October 20, 2023

**RE: Rise & Roast
9160 Coors Blvd. NW
Grading & Drainage Plan
Engineer's Stamp Date: 10/12/23
Hydrology File: C13D007**

GRADING & DRAINAGE PLAN

CG-101

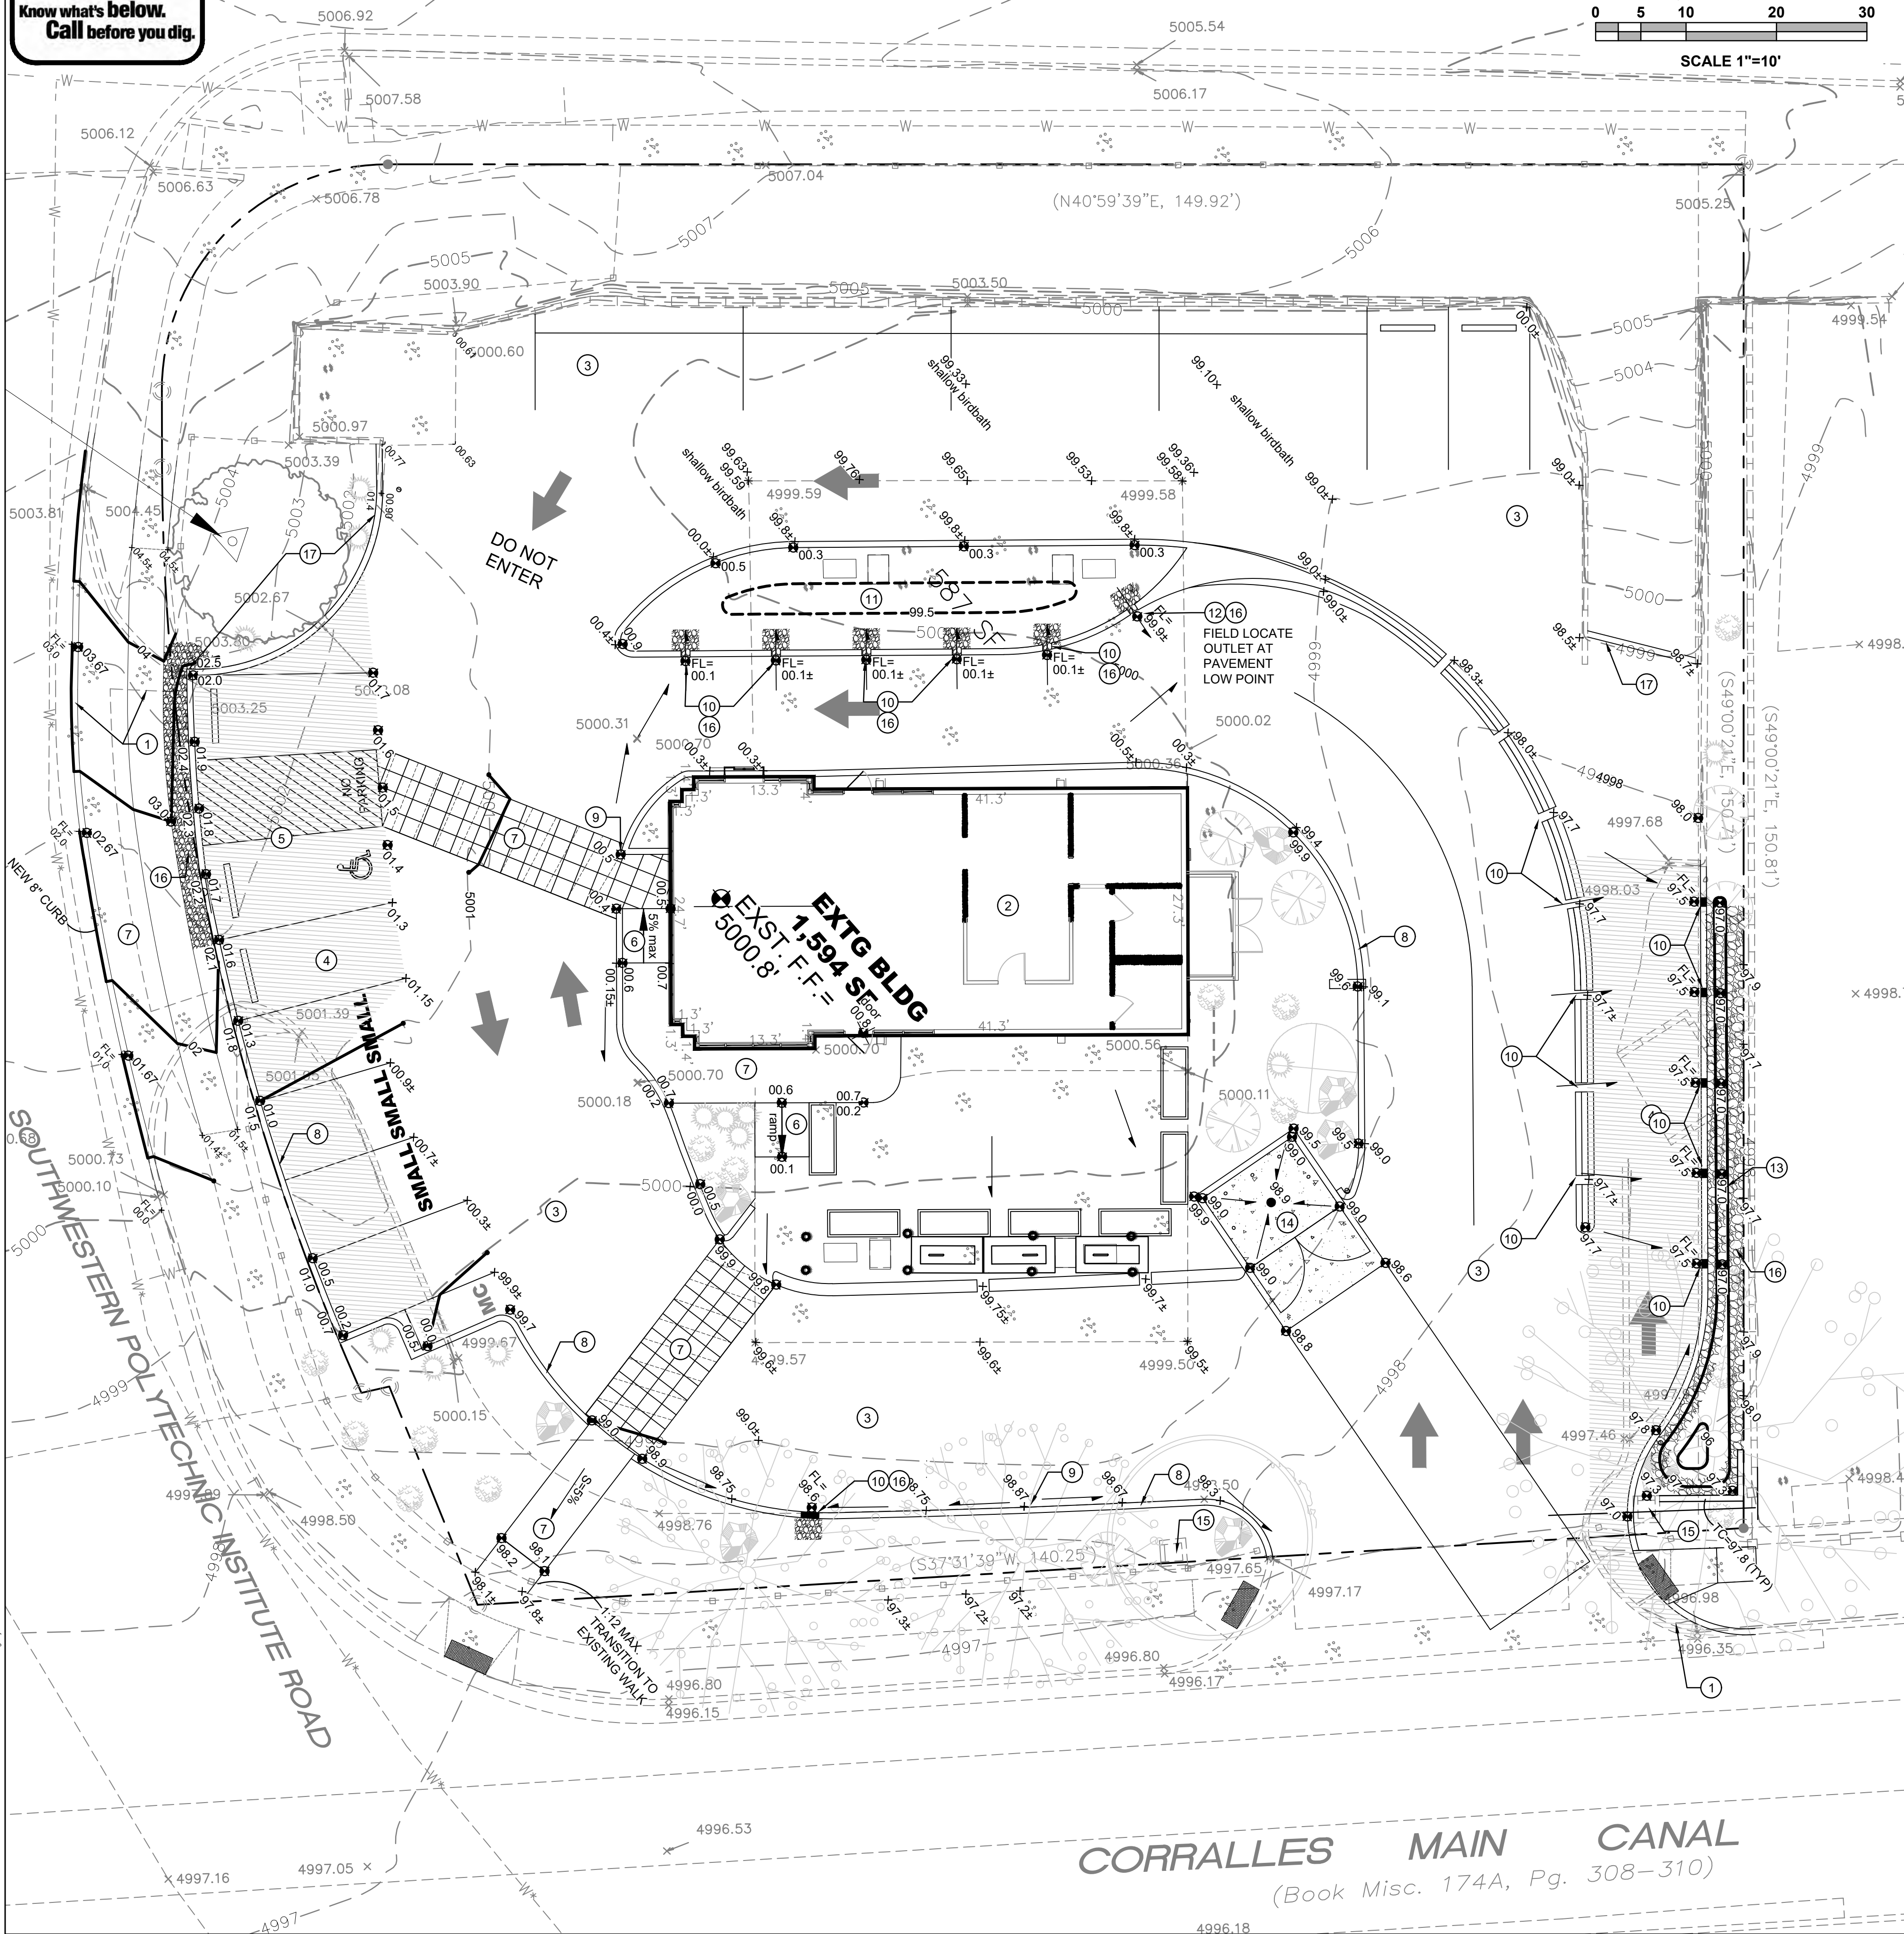
Based upon the information provided in your submittal received 10/13/2023, the Grading & Drainage Plan is approved for Building Permit and Grading Permit. Please attach a copy of this approved plan in the construction sets for Building Permit processing along with a copy of this letter.

1. Engineer's Certification, per the DPM Part 6-14 (F): *Engineer's Certification Checklist For Non-Subdivision* is required.

As a reminder, if the project total area of disturbance (including the staging area and any work within the adjacent Right-of-Way) is 1 acre or more, then an Erosion and Sediment Control (ESC) Plan and Owner's certified Notice of Intent (NOI) is required to be submitted to the Stormwater Quality Engineer (Dough Hughes, PE, jhughes@cabq.gov, 924-3420) 14 days prior to any earth disturbance.
